## 国際予備審査報告

出願人又は代理人 の書類記号 NEC-1519PCT	今後の手続きについては、国際予備審査報告の送付通知（様式PCT/IPEA/41.6）を参照すること。	
国際出願番号 PCT/JP03/08557	国際出願日 (日.月.年) 04.07.2003	優先日 (日.月.年) 16.07.2002
国際特許分類 (IPC) Int. Cl. 7 H04B 7/26, 17/00		
出願人（氏名又は名称） 日本電気株式会社

Translation of Amendment

(amendment under Article 34)

FIG. 5

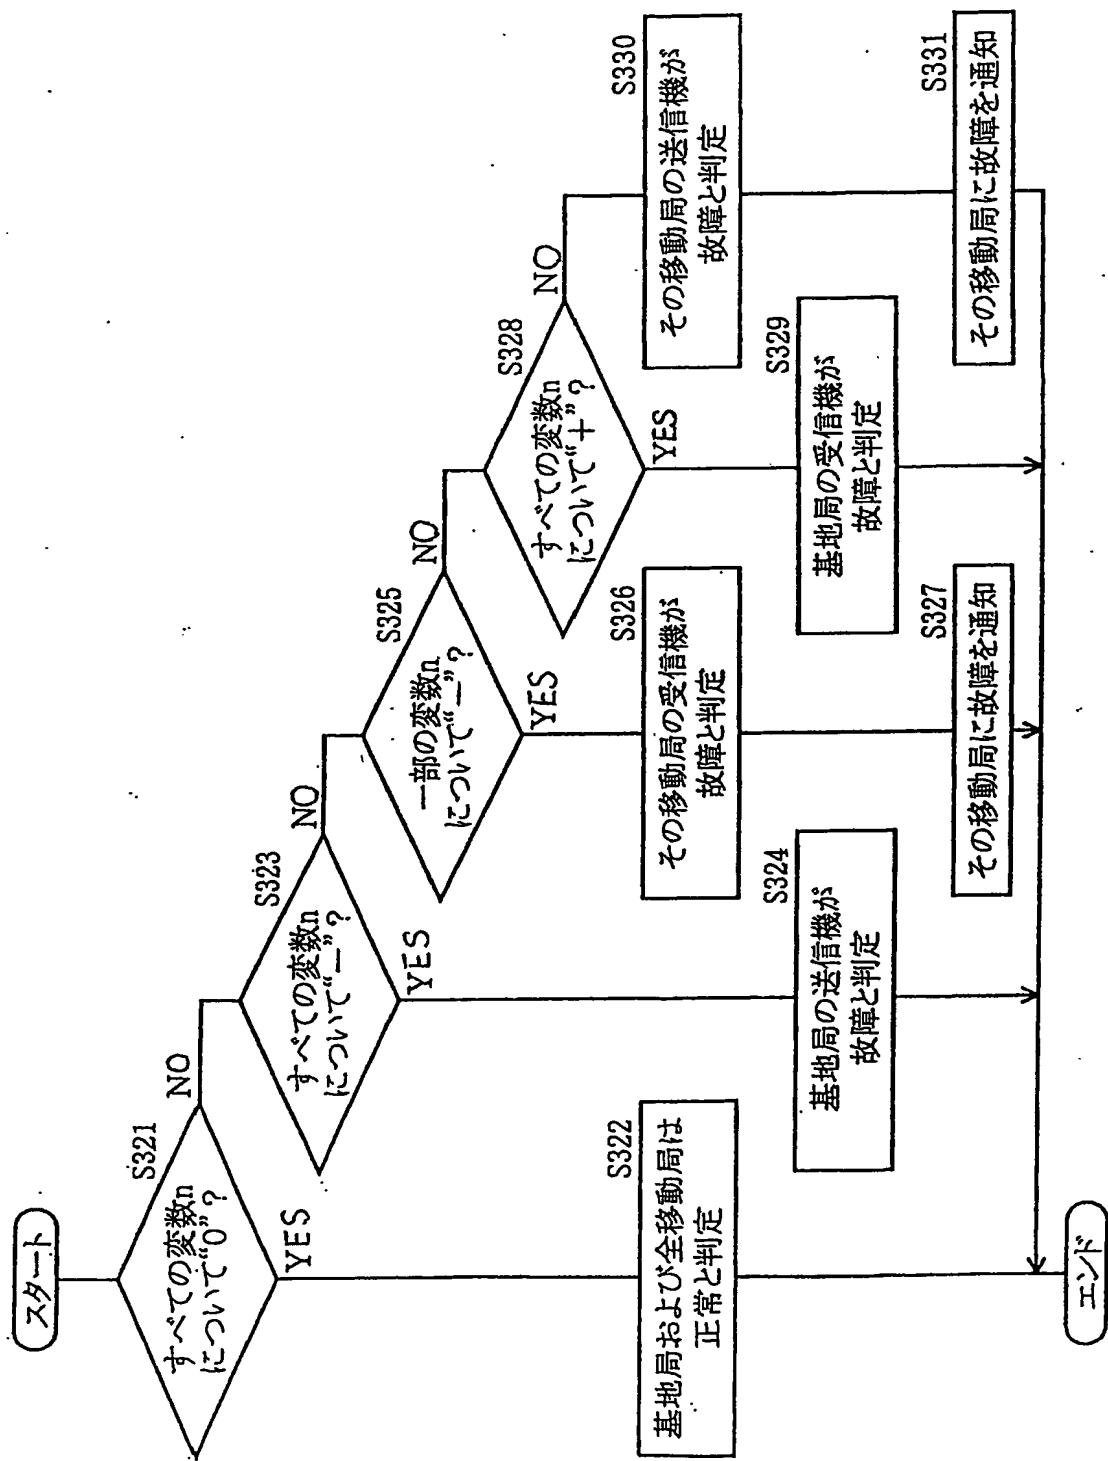
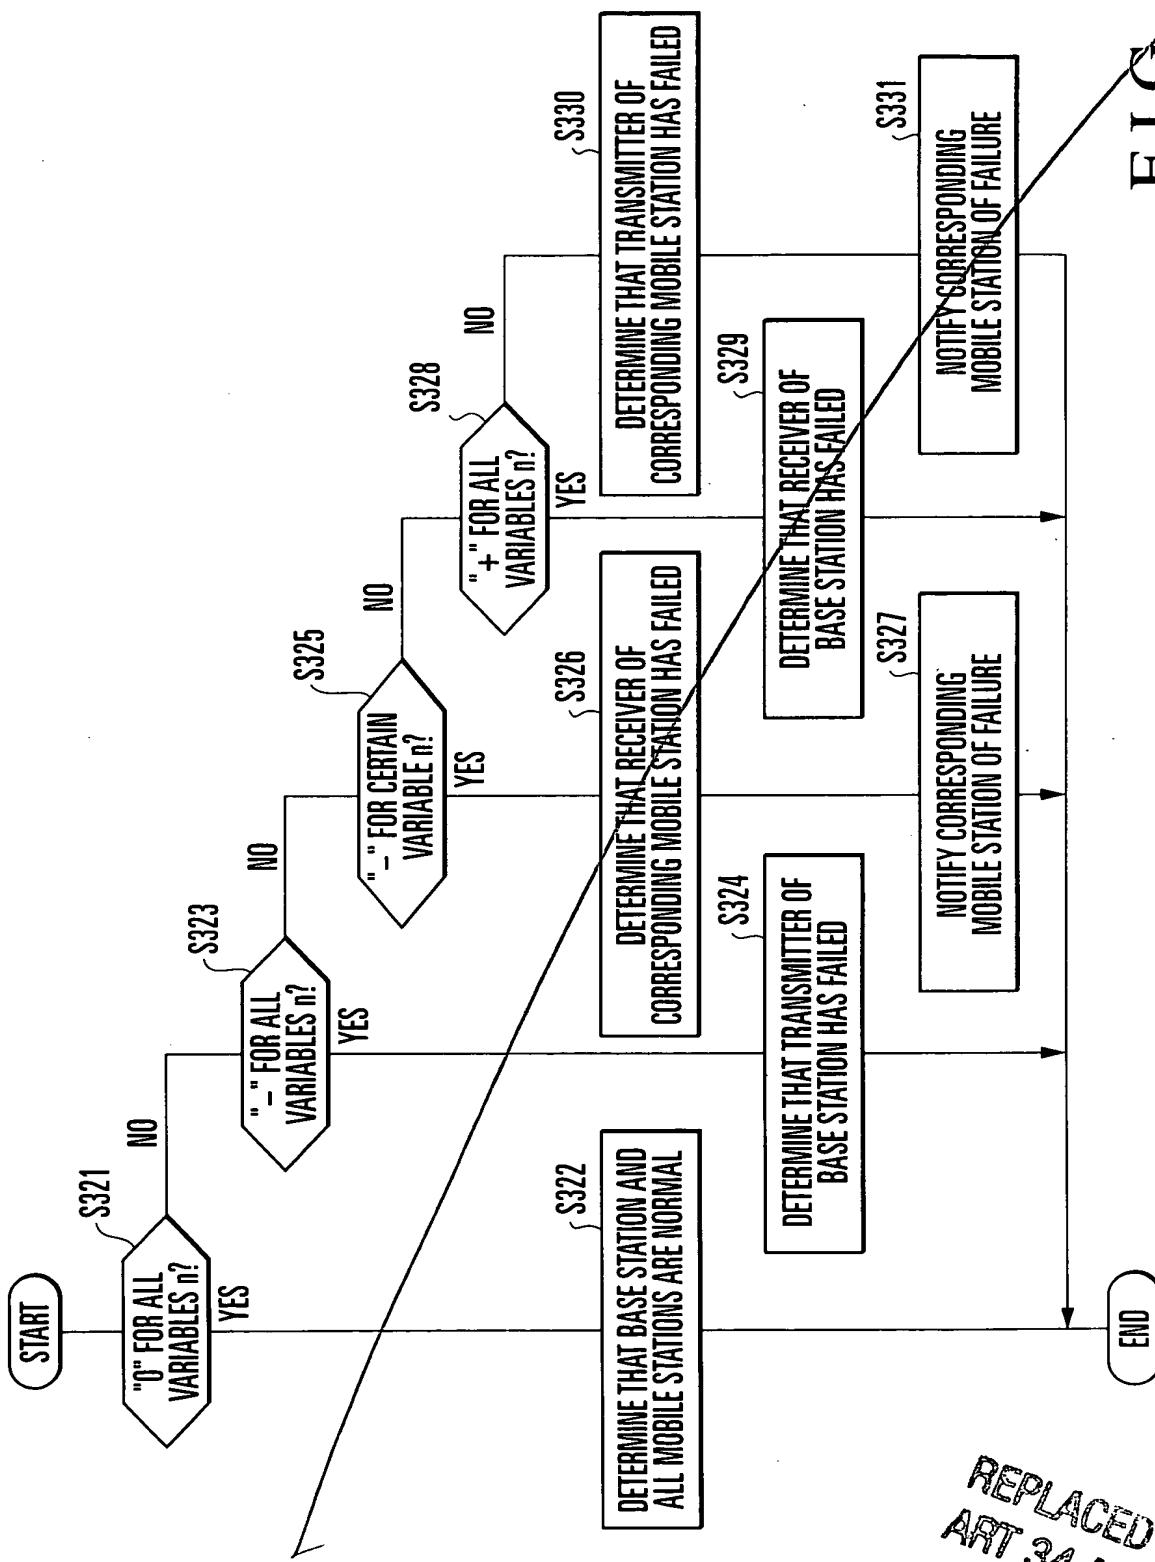
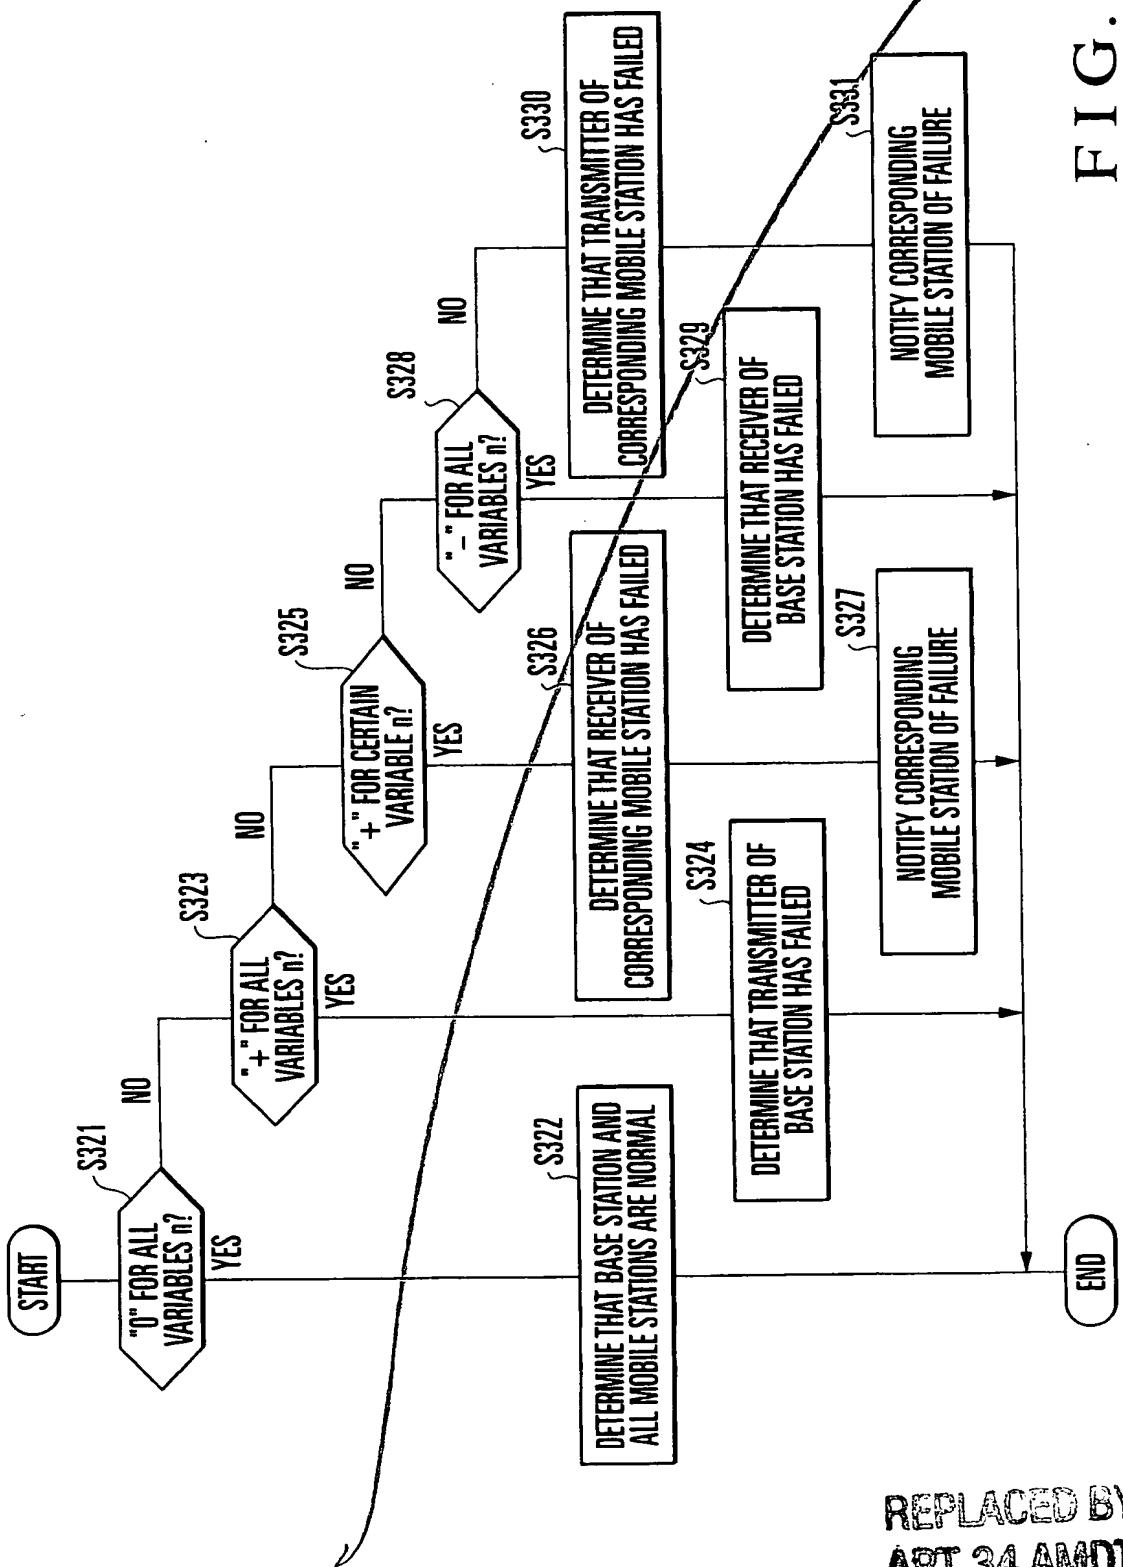
(3) Drawings, Page 5/6, steps S323 and S325  
in Fig. 5: Amend "+" to -----, and "--" to --+--.
